# UNITED STATES PATENT AND TRADEMARK OFFICE

10/709,846	06/01/2004	Ching-Huei Tsai	NAUP0572USA	3845
------------	------------	-----------------	-------------	------

<b>Office Action Summary</b>	<b>Application No.</b>	<b>Applicant(s)</b>	
	10/709,846	TSAI, CHING-HUEI	
	<b>Examiner</b>	<b>Art Unit</b>	
	Douglas W. Owens	2811

Regarding claims 1, 8, 9 and 11 Himes et al. teach a semiconductor wafer comprising (Fig. 8, for example):

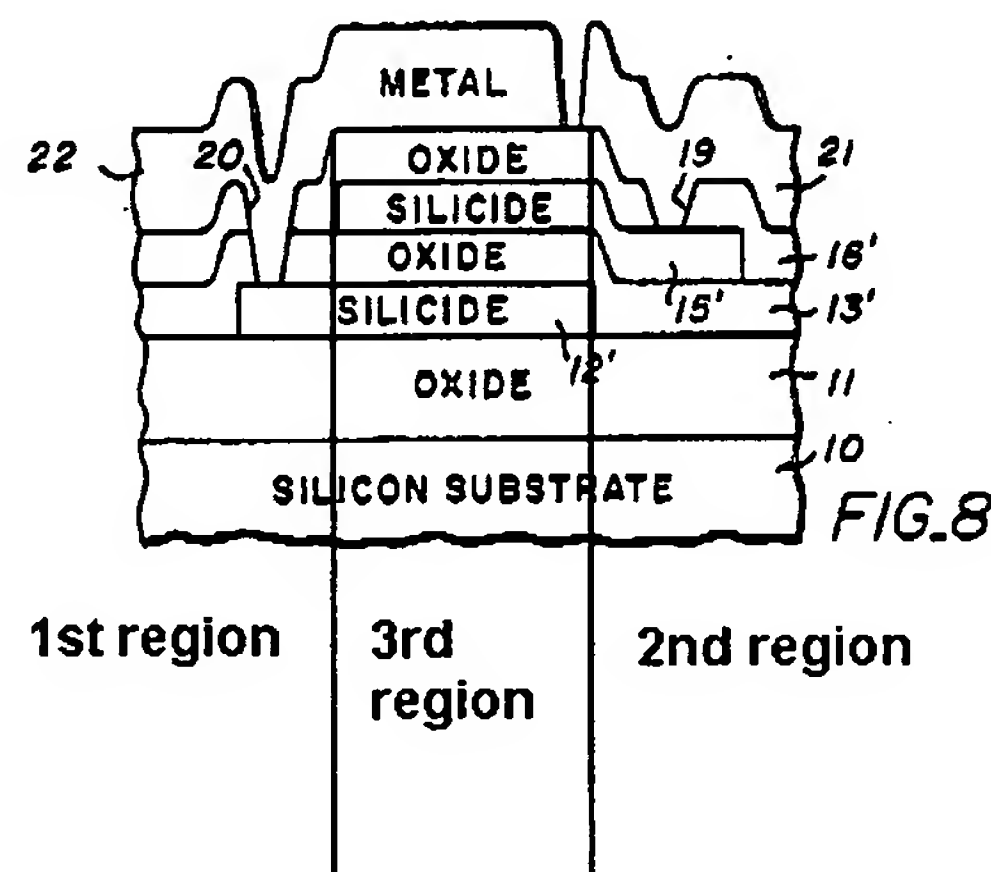
2. Claims 1 – 6 and 8 – 15 are rejected under 35 U.S.C. 102(b) as being anticipated by US Patent No. 4,731,696 to Himes et al.

a substrate with a first region (pictured below and right), a second region, and a third region horizontally defined on the surface of the substrate; and

a capacitor disposed on the substrate, the capacitor comprising:

a first polysilicon electrode (12'; Col. 1, lines 8 – 12) in the first region and the third region;

a first isolation layer (13') on the first electrode, the first isolation

layer covering a portion of the first electrode and the substrate; and

a second polysilicon electrode (15') on the first isolation layer, the second electrode covering the first electrode in the third region and covering the substrate in the second region.
